SERVICE INSTRUCTION SK-SI004 Rev B Page 1 of 5

SUBJECT: *BRIDLE CABLE CLAMP REPLACEMENT
(FOR GARMIN G3X AUTOPILOT PITCH SERVO)*

MODELS AFFECTED: *CCK-2000-0001 THROUGH -0072
CCX-2000-0001 THROUGH -0105
CCK-1865-0001 THROUGH -1061
CCX-1865-0001 THROUGH -0030
(IF TWO AXIS GARMIN G3X AUTOPILOT IS INSTALLED)*

Figure 4 – Hardware Detail

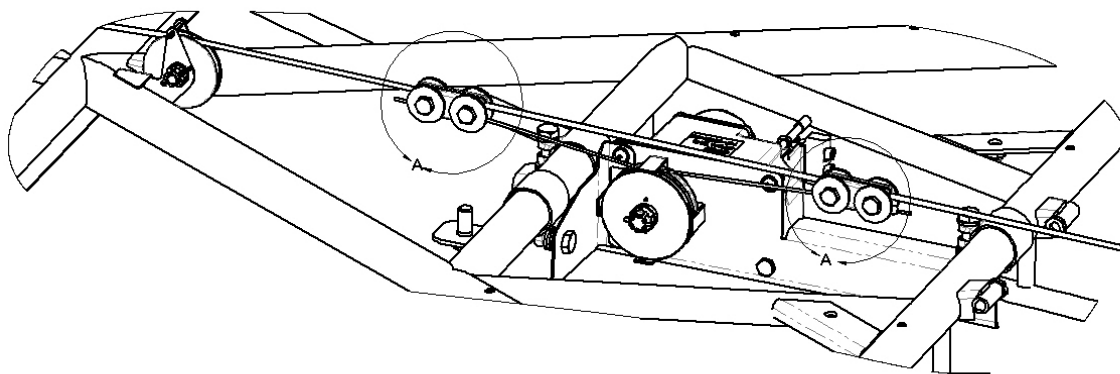
- Remove the front or rear clamp assembly. Loosen the nuts and remove the non-metallic clamp halves from the cables. Keep the bolts and washers, but discard the nuts.
- Line up two of the new metal clamp halves (SC71366-001) using the same bolt and washer hardware, but install new nylon nuts (supplied). Ensure the cables are seated and centered in each slot of the clamp assembly, with the larger elevator cable in the larger slot. Before the bolts are tightened, the cables should slide relatively easily through the slots in the clamp assembly when aligned correctly.
- Clock the new clamp assembly in the same orientation as the original, and ensure it is clear of all components throughout the entire range of the cable travel.

**Torque nuts
to 50 inch-lbs**

Figure 5 – New Aluminum Clamp Assembly Installed

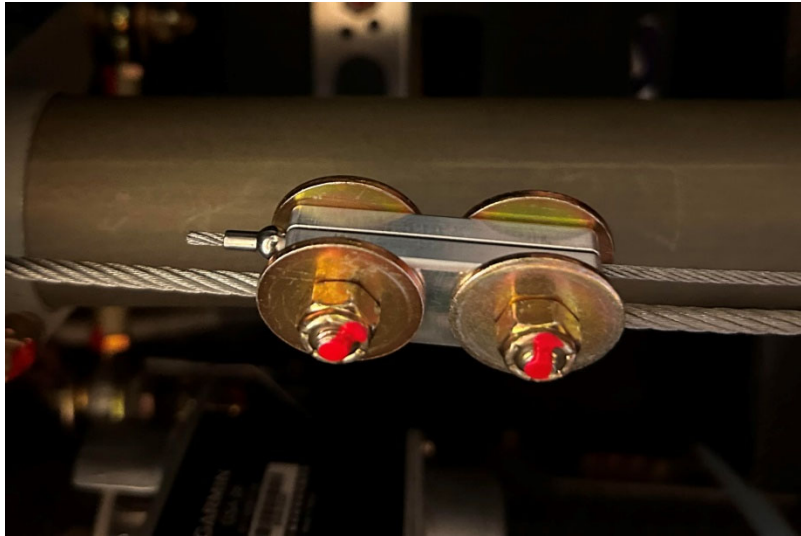
8. Using a pair of vice grips, pull the tail of the bridal cable so that the clamp assembly lines up with the marks you made showing the position of the original clamp assembly (it can be helpful to have a second person for this). **Torque the nuts to 50 inch-lbs.**
9. Now repeat the same process on the other clamp.
10. Confirm that the bridle cable is pulled taut with no slack on either side of the servo.
11. If the cable had heat shrink and it was removed during this operation, add new heat shrink tube using pieces that are 1.5 times the length of the tail of the bridal cable; place them so that the ends of the cable are securely covered to prevent any fraying.
